# ZONING COMMITTEE STAFF REPORT

1. **FILE NAME:** Alter Logistics **FILE #:** 21-236-272
2. **APPLICANT:** Alter Logistics **HEARING DATE:** February 25, 2021
3. **TYPE OF APPLICATION:** Conditional Use Permit
4. **LOCATION:** 795-801 Barge Channel Road
5. **PIN & LEGAL DESCRIPTION:** 09.28.22.34.0028; Lot 2, Block 1, Southport Barge Terminal
6. **PLANNING DISTRICT:** 3 **PRESENT ZONING:** I2, FF Flood Fringe
7. **ZONING CODE REFERENCE:** §§ 61.501, 72.74, 72.32
8. **STAFF REPORT DATE:** February 18, 2021 **BY:** Josh Williams
9. **DATE RECEIVED:** February 4, 2021 **60-DAY DEADLINE FOR ACTION:** April 4, 2021

A. **PURPOSE:** Conditional use permit to allow internal conveyance pits below the Regulatory Flood Protection Elevation (RFPE) in a new building to be constructed on fill elevated to the RFPE

2 A4.1 ENLARGED PLAN @ ALLEY 114 PITS
1/4" = 1'-0"

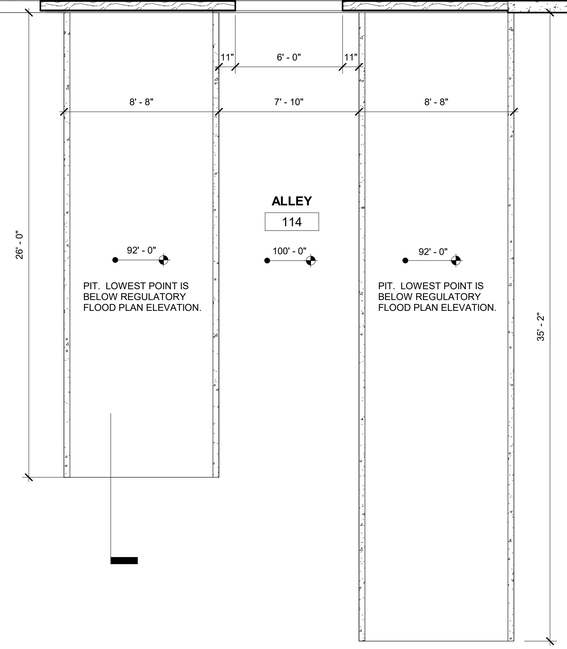
*1.* Alter Logistics proposes construction of a new fertilizer storage building. The proposed building will be elevated on fill to the regulatory flood plain elevations (RFPE), with the exception of two internal pits the bottom of which will be below the RFPE. Alter had intended to apply to the Federal Emergency Management Agency (FEMA) for a Letter of Map Revision for Fill (LOMR-F) which would have removed the area of the proposed building from the flood fringe district and allowed construction of the building, including the proposed pits, without the need for a CUP. However, the time needed to complete that process would have delayed construction which Alter intends to commence spring 2021 pending City approvals. As an alternative, Alter has applied for a CUP to allow for the internal pits to be lower than the RFPE, subject to applicable requirements of Ch. 72 of the Saint Paul code.

These standards can be met. The building is proposed to be built at the Regulatory Flood Protection Elevation (RFPE), approximately 708 feet above sea level. The proposed internal pits to be located below the RFPE fall under the definition of basement in § 72.14. They are proposed to be constructed to the FP-1 or FP-2 floodproofing standard and meet all other requirements of § 72.74(c). As a condition of approval, the applicant should be required to provide plans and as-built drawings signed by a registered professional engineer or other qualified professional certifying consistency with the requirements of § 72.74(a)(1) and § 72.74(c).

(h) *The susceptibility of the proposed facility and its contents to flood damage and the effect of such damage on the individual owner.* The proposed building will be elevated to the RFPE and the proposed internal pits located below the RPFE should be floodproofed to the FP-1 or FP-2 standard as a condition of approval.

(k) *The danger that materials may be swept onto other lands or downstream to the injury of others.* The proposed facility will be located in the flood fringe, where water velocities are generally minimal. As a condition of approval, the portion of the building below the RFPE should be built to applicable floodproofing standards.

1. Site plan approval.
2. Final plans approved by the Zoning Administrator for this use shall be in substantial compliance with the plan submitted and approved as part of this application.
3. The applicant shall submit plans and as-built documentation for the internal pits signed by a registered professional engineer or other qualified professional certifying construction of the internal pits below the RFPE to the FP-1 or FP-2 floodproofing standard, as well as an elevation certificate.
